REV.
A

AS9759

BOLT, MACHINE - DOUBLE HEXAGON EXTENDED WASHER HEAD, DRILLED, PD SHANK, AMS4967 (TI 6AL-4V), .1900-32 UNJF-3A

FIGURE 1 - BOLT

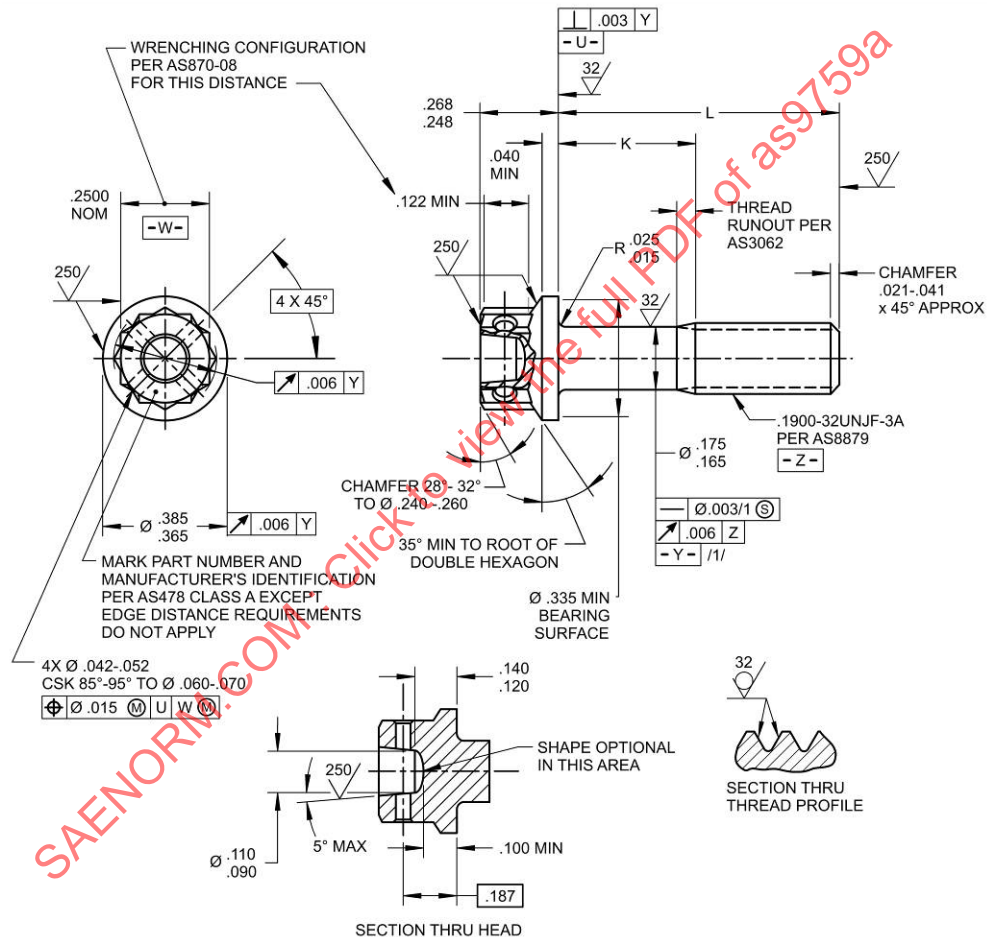
GENERAL REVISION. REVISE LIGHTENING HOLE CONFIGURATION (ADD SECTION VIEW) TO ALLOW OPTIONAL SHAPE AT BOTTOM OF HOLE, ADD EXCEPTION TO EDGE DISTANCE REQUIREMENTS FOR HEAD MARKING, UPDATE THREAD SPECIFICATION TO AS8879, UPDATE SURFACE FINISH REQUIREMENTS, ADD AS3062 AND DELETE NOTE ON FILLET FOR INCOMPLETE THREAD REQUIREMENTS, ADD DATUM REQUIREMENTS FOR -.03 THRU -.14 LENGTHS (NEW NOTE 1), UPDATE DIMENSIONING AND TOLERANCING TO ANSI Y14.5M-1982, DELETE .015 MAX RADIUS AT BASE OF WRENCH PAD, DELETE HARDNESS NOTE, AND FIGURE 1 REDRAWN.
